LAND REAR OF CHURCH ROAD, WORTHENBURY PLANNING APPLICATION – P/2021/0032 CONSULTATION RESPONSE

PROJECT:
LAND REAR OF CHURCH ROAD
WORTHENBURY

TITLE:
PROPOSED WASTEWATER
OUTFLOW LOCATION PLAN

Figure 1: Proposed Wastewater Outfall Location (Betts Hydro, 2022)

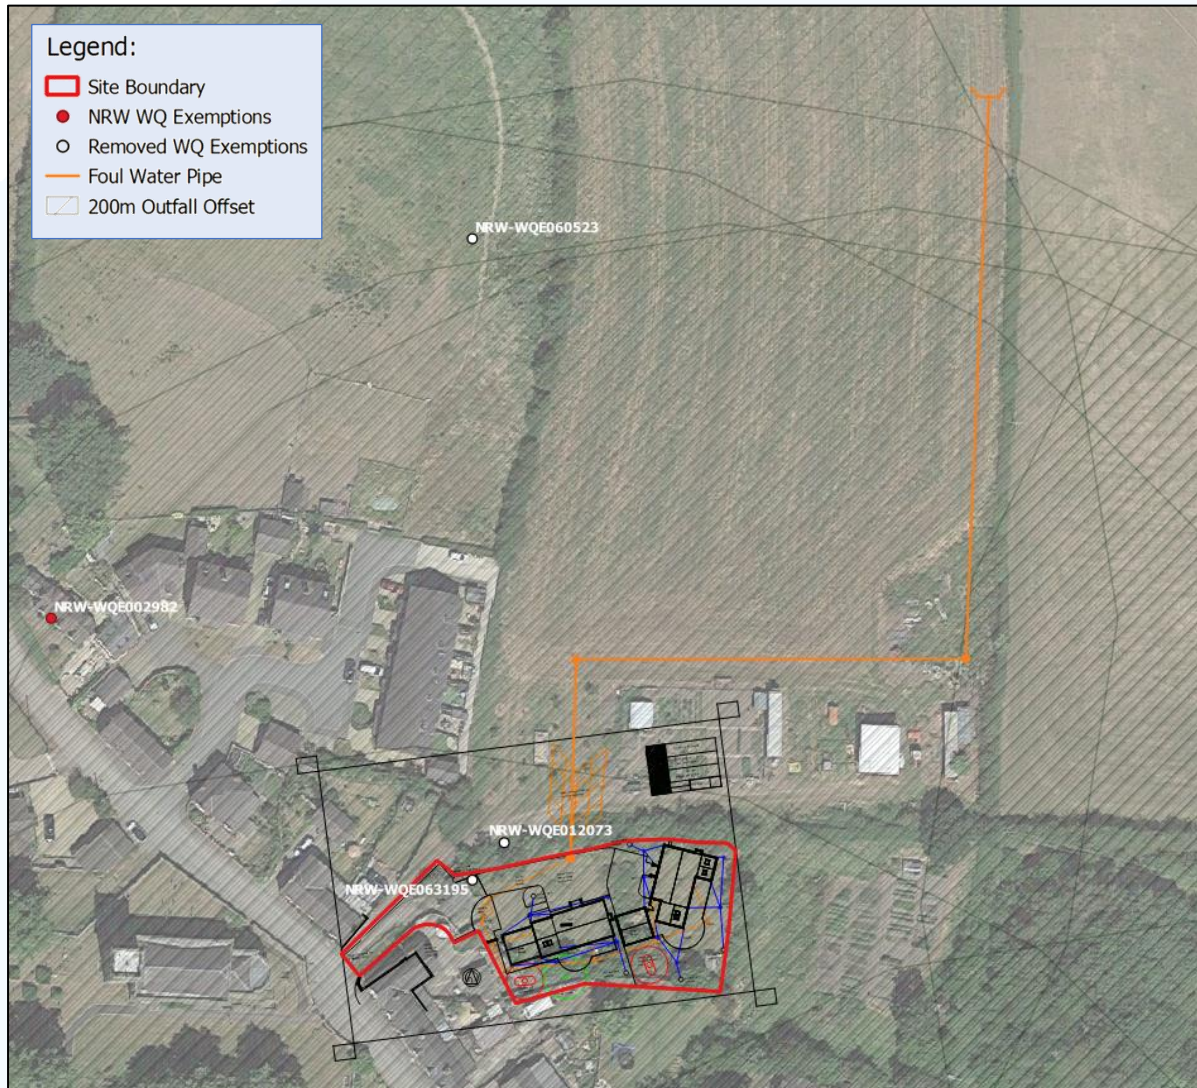
Current policy also states that "to ensure that there is no significant in combination effect, the discharge to ground should be at least 200m from any other discharge to ground. The density of discharges to ground should also not be greater than 1 for every 4ha (or 25 per km²)".

To conform to the above policy, the location of the proposed wastewater outfall has been reviewed in relation to existing points of discharge to ground, identified by NRW's free datasets

(see plan in **Appendix B**). A new location has therefore been proposed for the wastewater outfall, as shown in **Figure 1**. To identify the proposed location for a suitable outfall, the "NRW_DS123318_WQ_Exemptions" dataset provided by NRW was reviewed. Initially, an outfall into the field adjacent to the northern boundary of the site was not possible due to the presence of three existing points of discharge to ground.

With the removal of the three points of outfall, a suitable location was identified within the north-eastern corner of the field located adjacent to the northern boundary of the site. It is understood that this location is policy compliant as it is not located within 200m of another point of outfall.

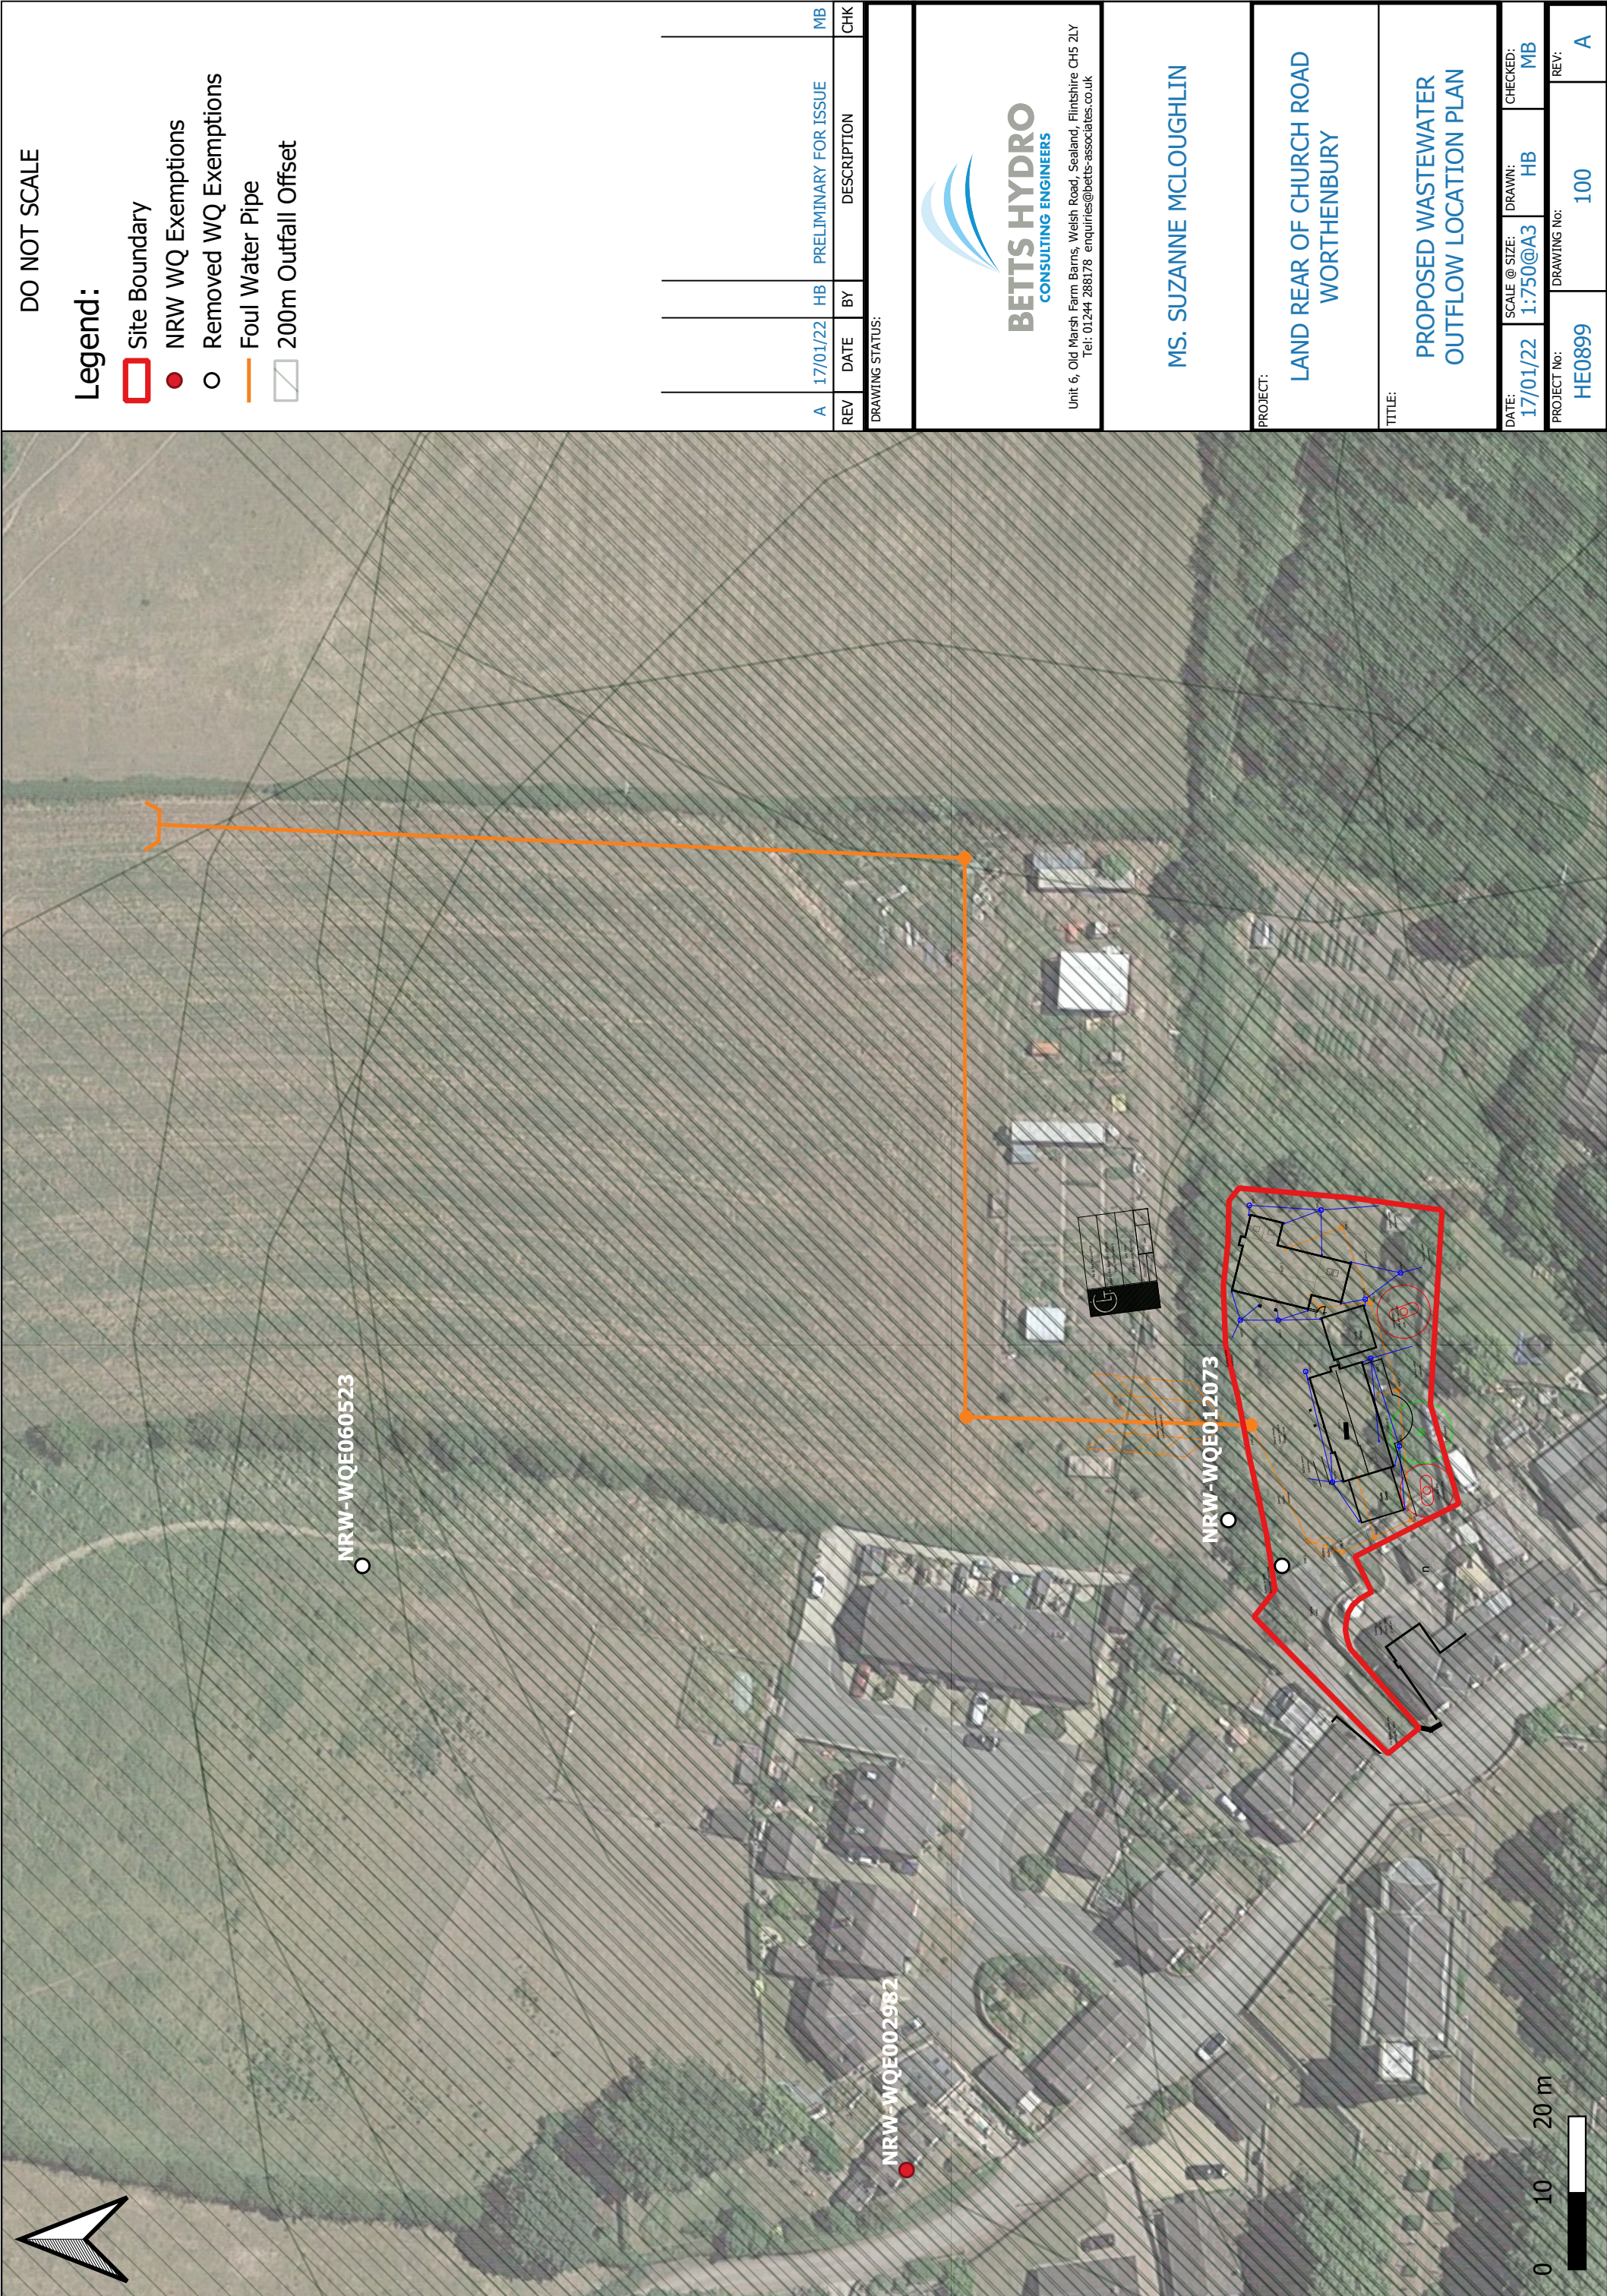
In relation to point 3, we would advise that an updated plan should be submitted to the Local Planning Authority in order to provide confirmation of the location of the proposed drainage field. However, in principle, we can confirm that provided there are no other discharges to ground within 200m of the location, the application should screen out in accordance with our [Advice to planning authorities for planning applications affecting phosphorus sensitive river Special Areas of Conservation](#).
